**SERVICE BULLETIN**

**N° 189-299**

**ATA 53 - INTERMEDIATE GEARBOX HINGED ACCESS PANEL RETROMOD**

This Service Bulletin is issued in order to provide the necessary instruction on how to perform the IGB hinged access panel retromod P/N 8G5355P00511.

**Figure 1**

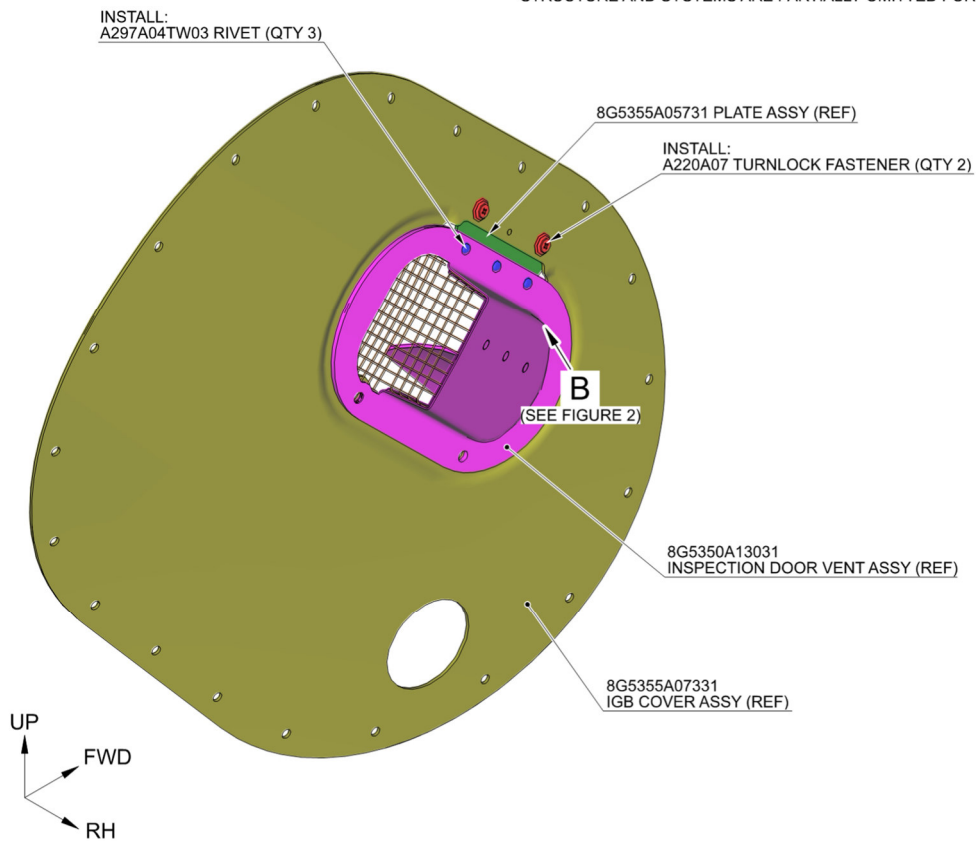
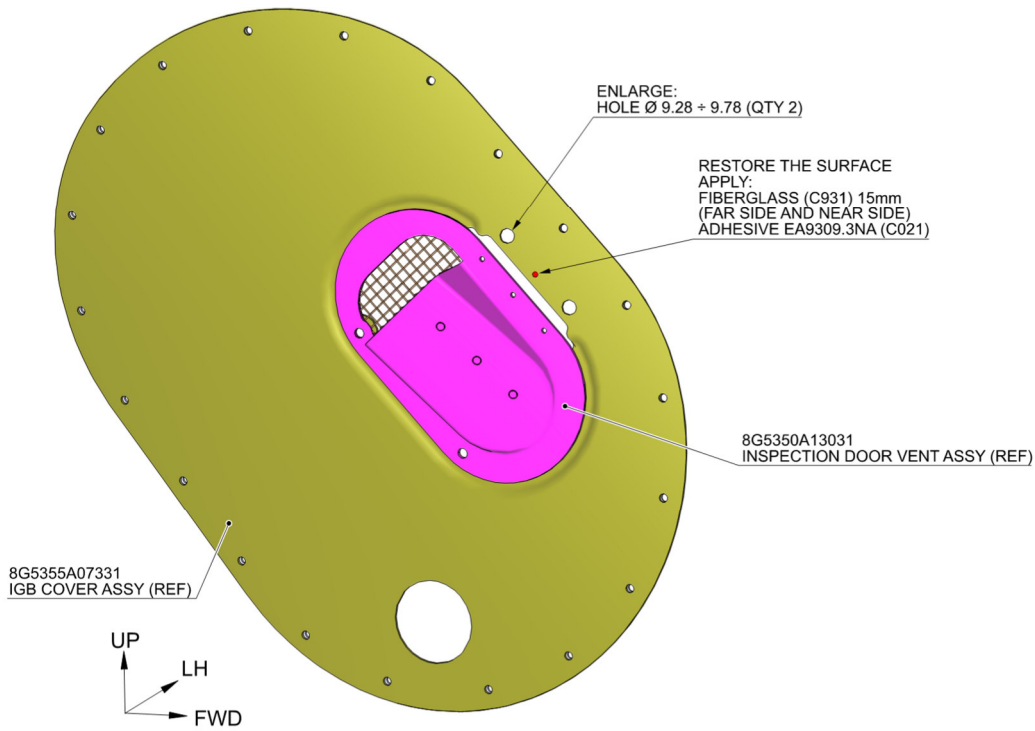
- 2.1 With reference to Figure 1 View A "Was", remove the hinge P/N MS20257P3-300 and n°6 existing rivets from the IGB cover assy P/N 8G5355A07331 and the inspection door vent assy P/N 8G5350A13031.

- 2.4 With reference to Figure 1 View A “Becomes” and Figure 2 View C, install the plate assy P/N 8G5355A05731 to the inspection door vent assy P/N 8G5350A13031 by means of n°3 rivets P/N A297A04TW03 and to the IGB cover assy P/N 8G5355A07331 by means of n°4 turnlock fasteners P/N A220A07.
3. In accordance with AMP DM 89-A-06-41-00-00A-010A-A, re-install the reworked access panel 493A.
4. Return the helicopter to flight configuration and record for compliance with this Service Bulletin on the helicopter logbook.
5. Gain access to My Communications section on Leonardo WebPortal and compile the “Service Bulletin Application Communication”.

**Figure 2**

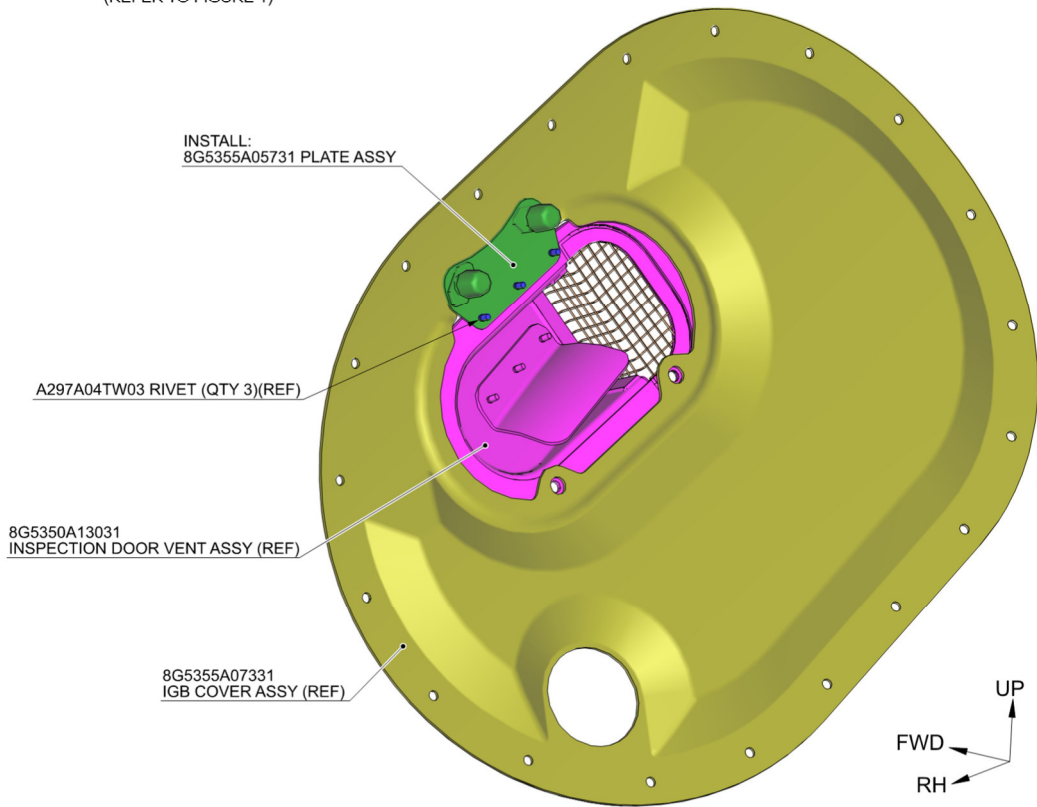
- 2.2 With reference to Figure 2 View B, enlarge n°2 existing holes up to  $\varnothing 9.28 \div 9.78$  thru the IGB cover assy P/N 8G535A07331.

- 2.3 With reference to Figure 2 View B, fill the redundant hole in the IGB cover assy P/N 8G5355A07331 in accordance with the following procedure:
  - 2.3.1 Sand lightly to remove raised or rough surface.
  - 2.3.2 Apply 15mm layer of fiberglass (C931) with a brush on the far side of the hole indicated. Cover with release film.

- 2.3.3 Apply adhesive EA9309.3NA (C021) inside the hole using a spatula or tongue depressor.
- 2.3.4 Apply 15mm layer of fiberglass (C931) with a brush on the uncovered side of the hole. Cover with release film.
- 2.3.5 When cure is complete, remove the material covering the repair and clean the surface by lightly sanding.
- 2.3.6 Perform a visual inspection after the repair to verify the repaired area restores the contour and is sanded smooth and blended flush to the part.
